BIOIMPACT, INC.  
P.O. BOX 132 KINGSHILL  
ST. CROIX, U.S. VIRGIN ISLANDS 00851  
340 690-8445 FAX 340 718-3800  
bioimpact@islands.vi, [bioimpact.islands.vi@gmail.com](mailto:bioimpact.islands.vi@gmail.com)

January 4, 2024

RE: SAJ-2004-12518 Summers End Response to RAI December 19, 2023

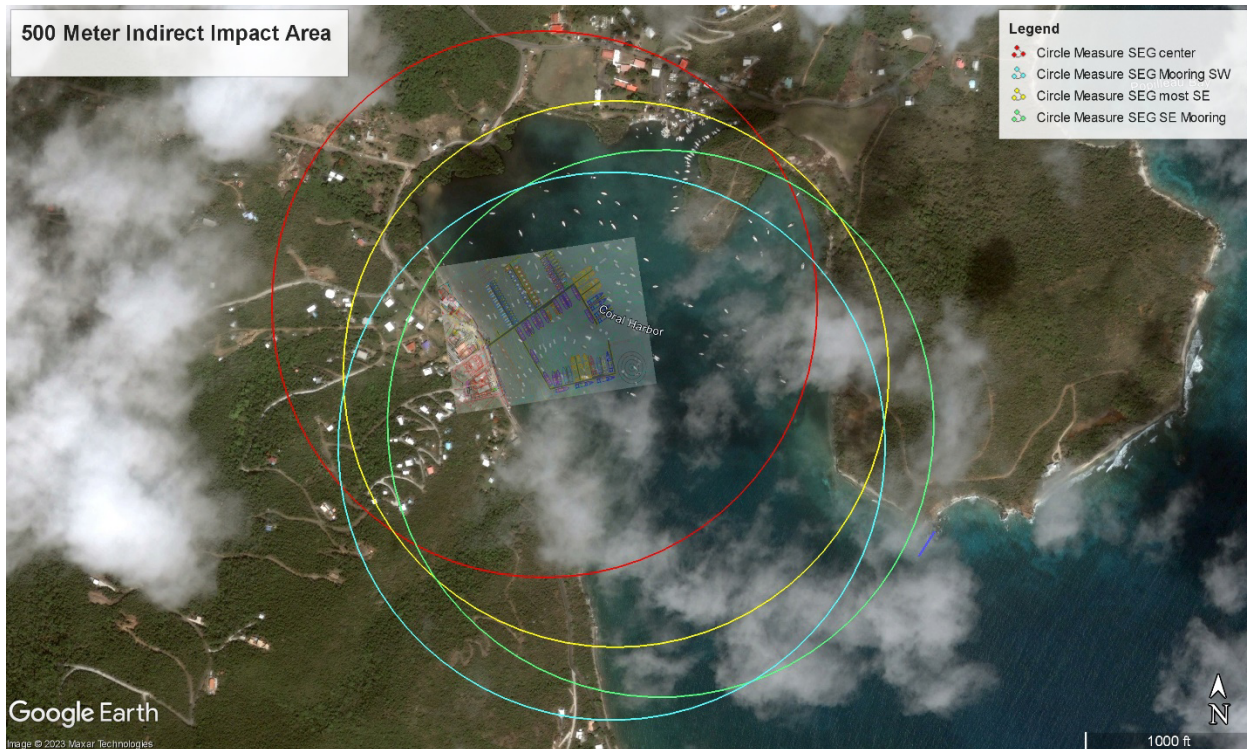
*3. Please provide a table outlining the direct and indirect impacts. Include impacts to mangroves, seagrasses, listed and non-listed corals.*

The Excel table provided includes both the direct and indirect impacts to the marine habitats including the mangroves, seagrass beds and all corals, ESA listed and non-ESA-listed corals.

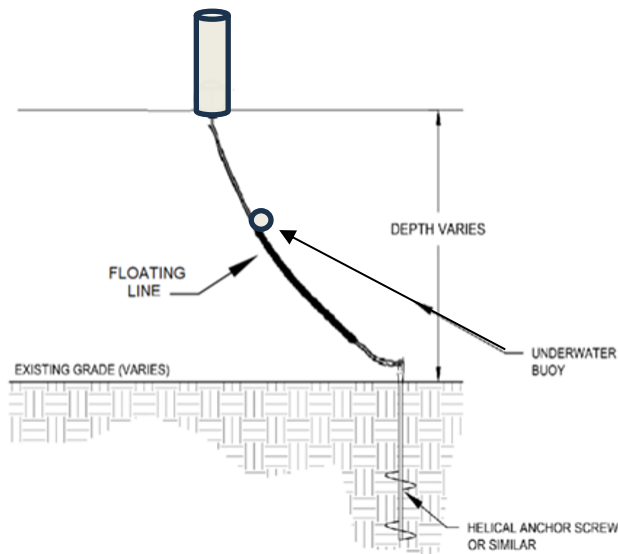
j. Quadrats shall be placed, in respect to ESA-listed corals, to capture all species present.

The monitoring quadrats will be placed in respect to ESA corals to capture all species (coral, sponges and other sessile organisms).

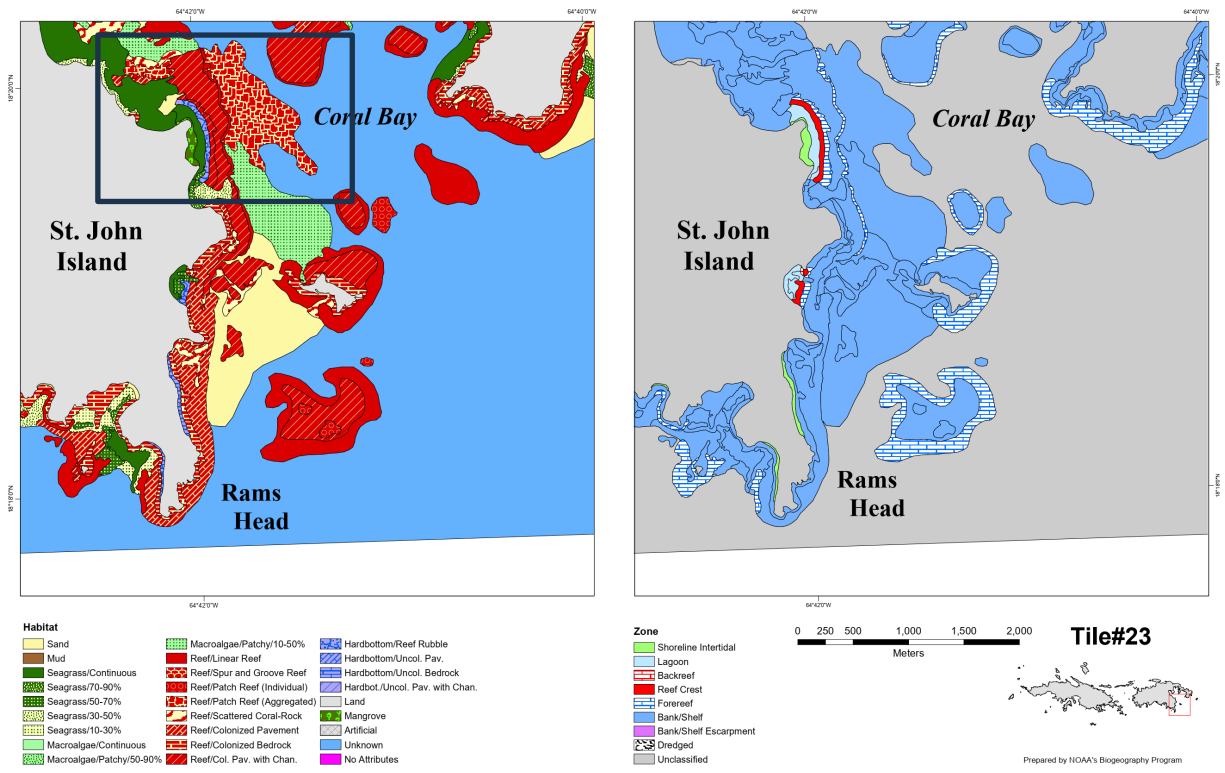
b. Here is a link for the educational signage:

The appropriate educational signage as suggested will be posted throughout the marina and as appropriate on the shoreline.
